SUBJECT: AMENDMENT NO. 144 TO FACILITY OPERATING LICENSE NO. DPR-43,
KEWAUNEE NUCLEAR POWER PLANT (TAC NO. MA2284)

AMENDMENT TO FACILITY OPERATING LICENSE

Amendment No. 144
License No. DPR-43

ATTACHMENT TO LICENSE AMENDMENT NO. 144

FIGURE TS 3.1-1

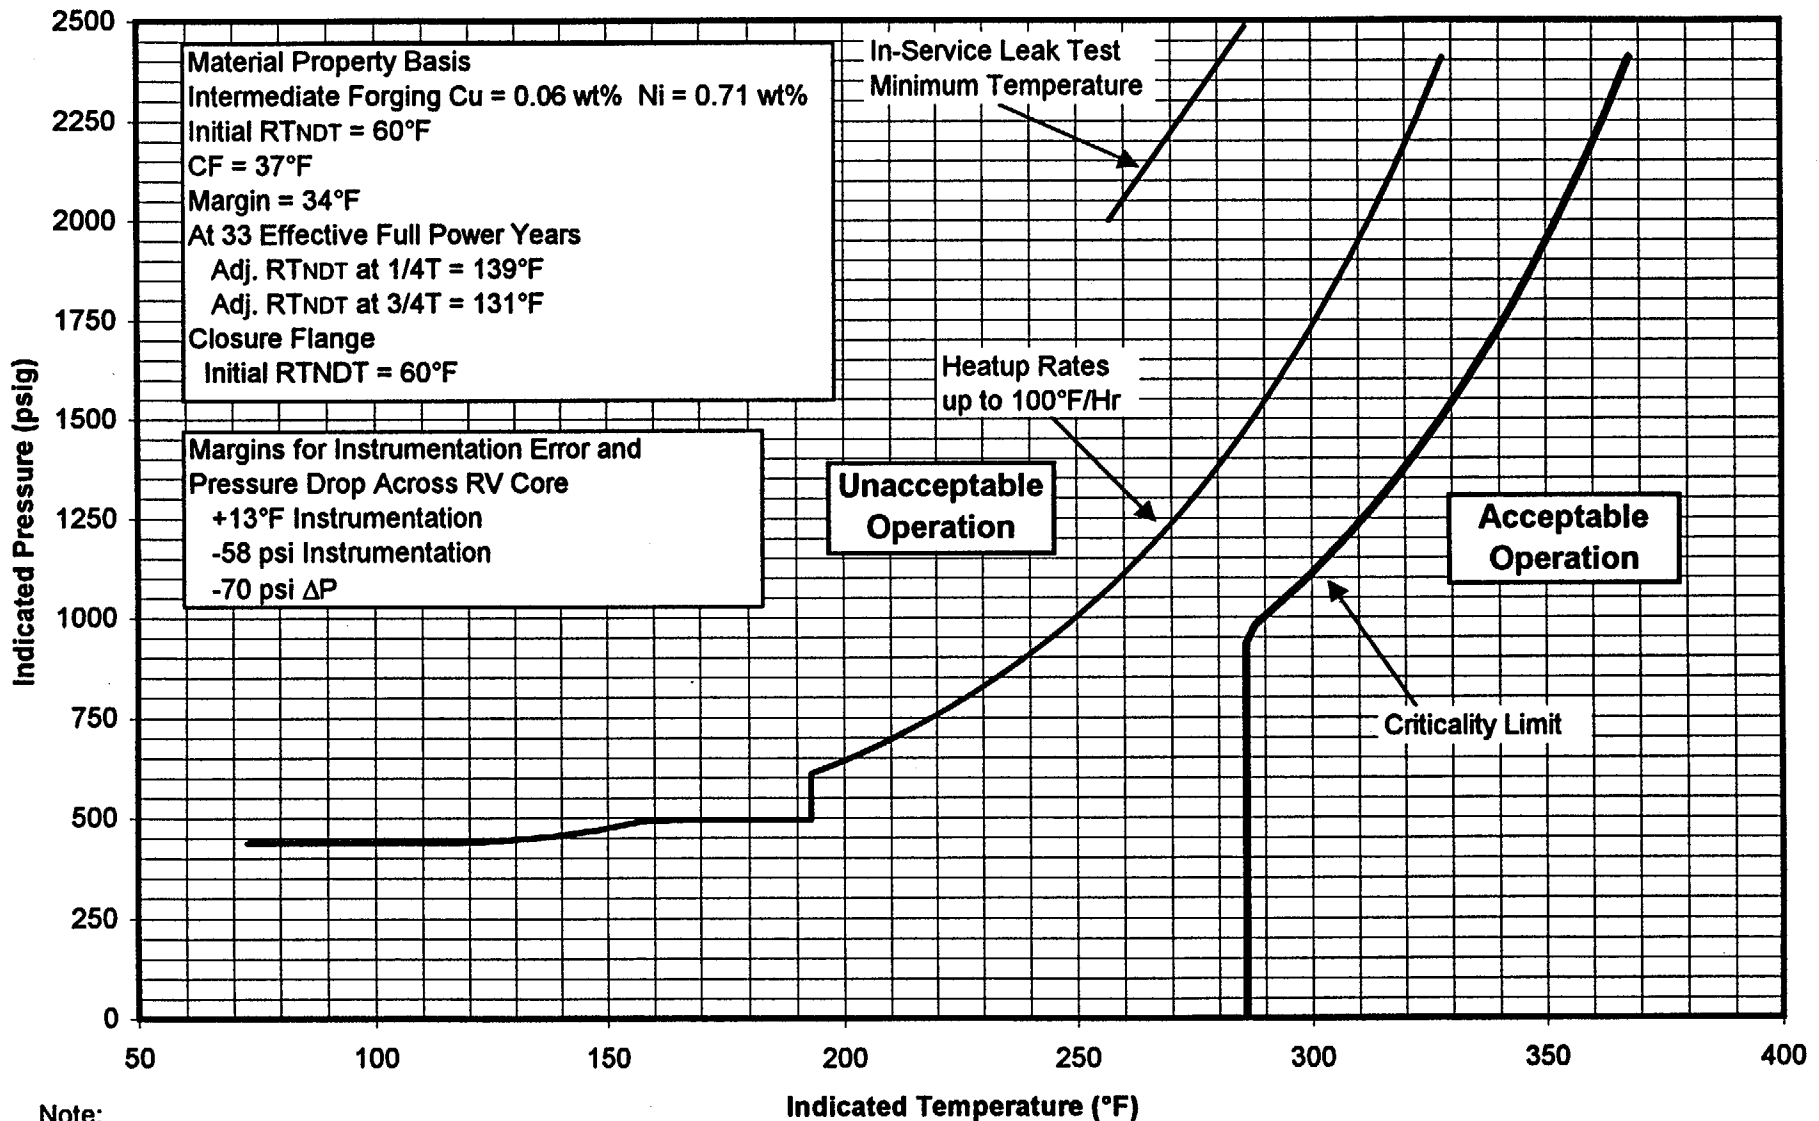
1. The reactor coolant temperature and pressure and system heatup and cooldown rates (with the exception of the pressurizer) shall be limited in accordance with Figures TS 3.1-1 and TS 3.1-2. Figures TS 3.1-1 and TS 3.1-2 are applicable for the service period of up to 33^[1] effective full-power years.

- A. Allowable combinations of pressure and temperature for specific temperature change rates are below and to the right of the limit lines shown. Limit lines for cooldown rates between those presented may be obtained by interpolation.

- B. Figures TS 3.1-1 and TS 3.1-2 define limits to assure prevention of non-ductile failure only. For normal operation other inherent plant characteristics, e.g., pump heat addition and pressurizer heater capacity may limit the heatup and cooldown rates that can be achieved over certain pressure-temperature ranges.

The staff has determined, based on its independent assessment described above, that the proposed P/T curves, shown in Figures 1 and 2 of this SE, meet the requirements of 10 CFR Part 50, Appendix G to a fluence of 2.85×10^{19} n/cm² ($E \geq 1$ MeV) corresponding to 28 EFPY. The application, as modified by the March 9, 1999, supplement is acceptable.

FIGURE TS 3.1-2

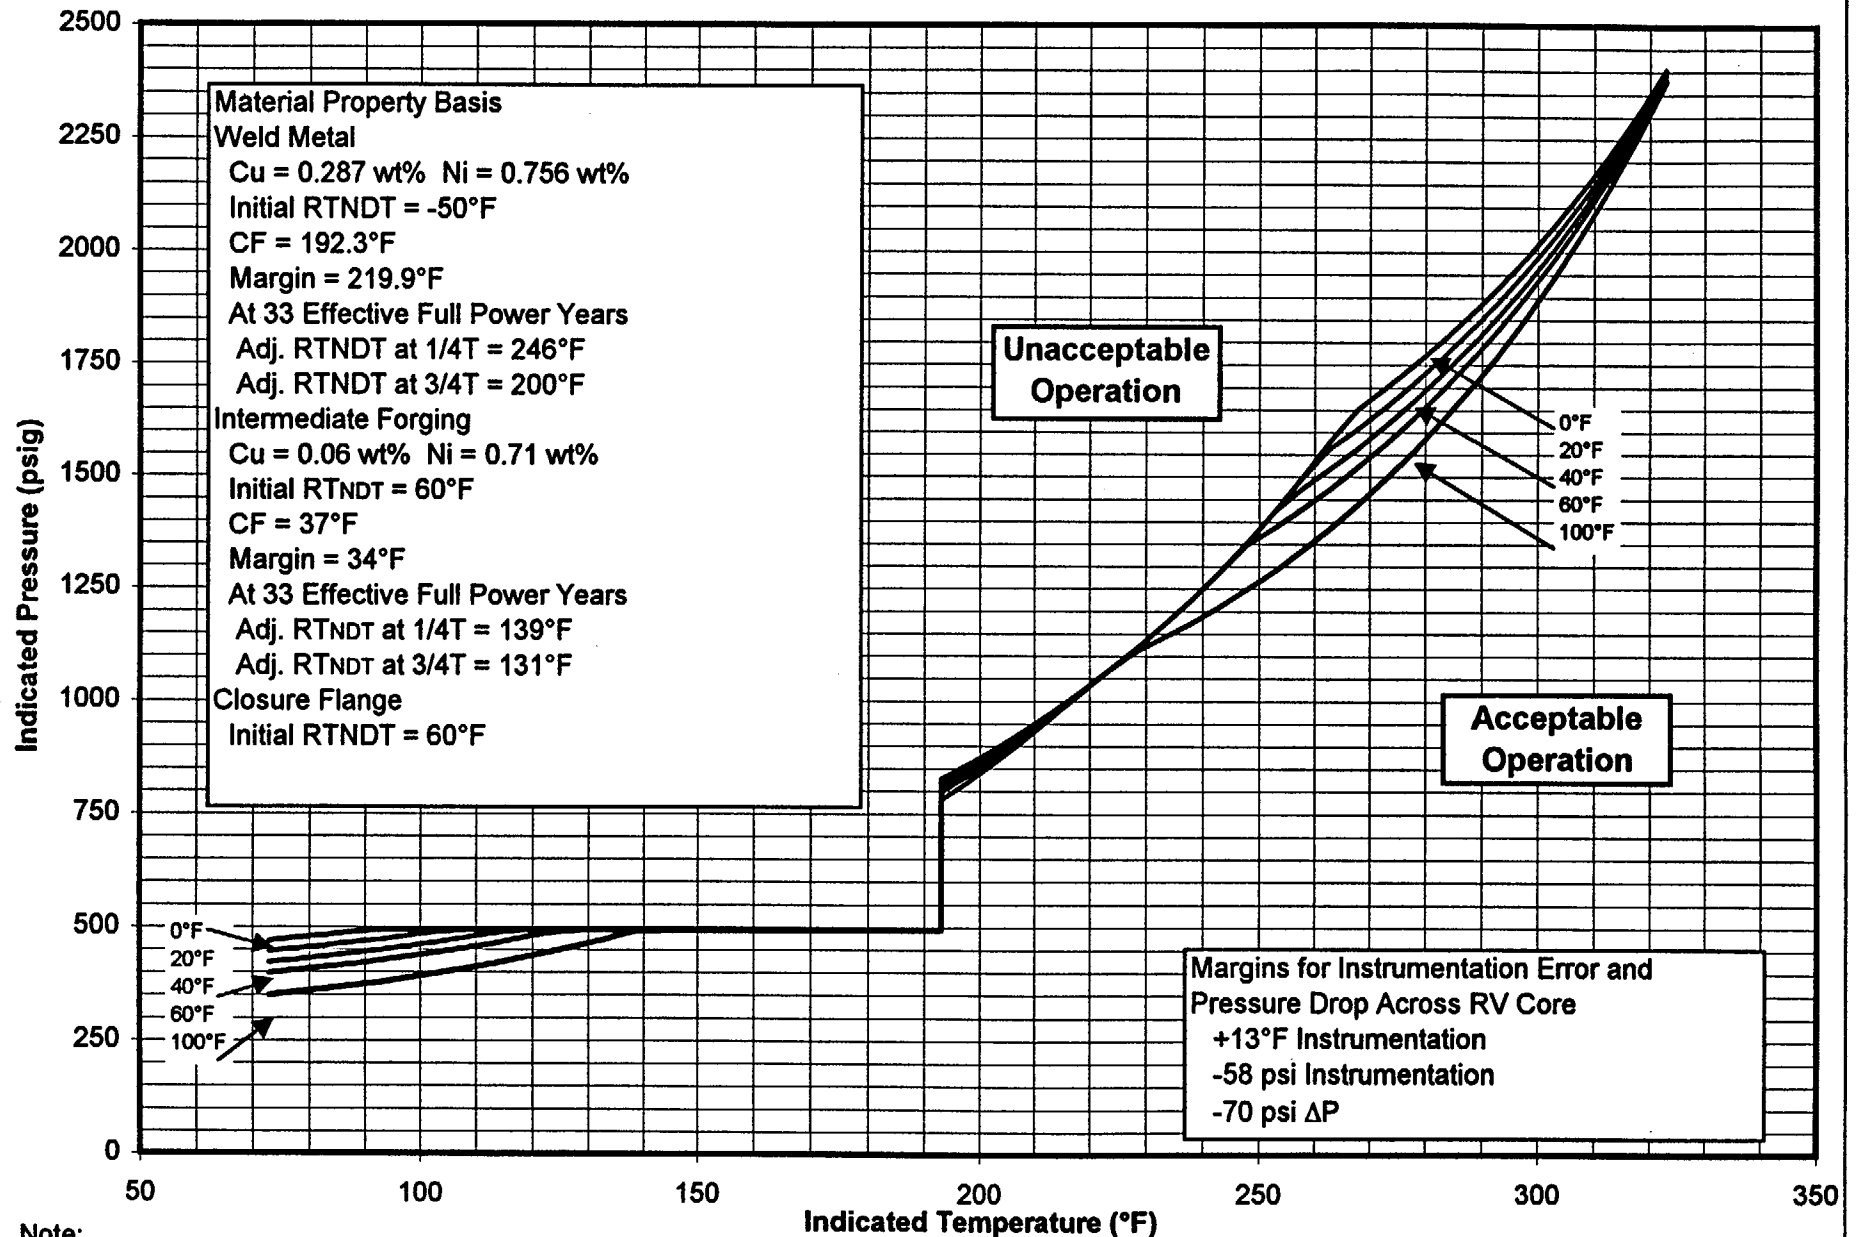
- C. The isothermal curve in Figure TS 3.1-2 defines limits to assure prevention of non-ductile failure applicable to low temperature overpressurization events only. Application of this curve is limited to evaluation of LTOP events whenever one or more of the RCS cold leg temperatures are less than or equal to the LTOP enabling temperature of 200°F.

The isothermal cooldown limit curve (Figure TS 3.1-2) is used for evaluation of low temperature overpressure protection (LTOP) events. This curve is applicable for 33⁽¹¹⁾ effective full-power years of fluence (through the end of operating cycle 33⁽¹¹⁾). If a low temperature overpressure event occurred, the RCS pressure transient would be evaluated to the limits of this figure to verify the integrity of the reactor vessel. If these limits are not exceeded, vessel integrity is assured and a TS violation has not occurred.
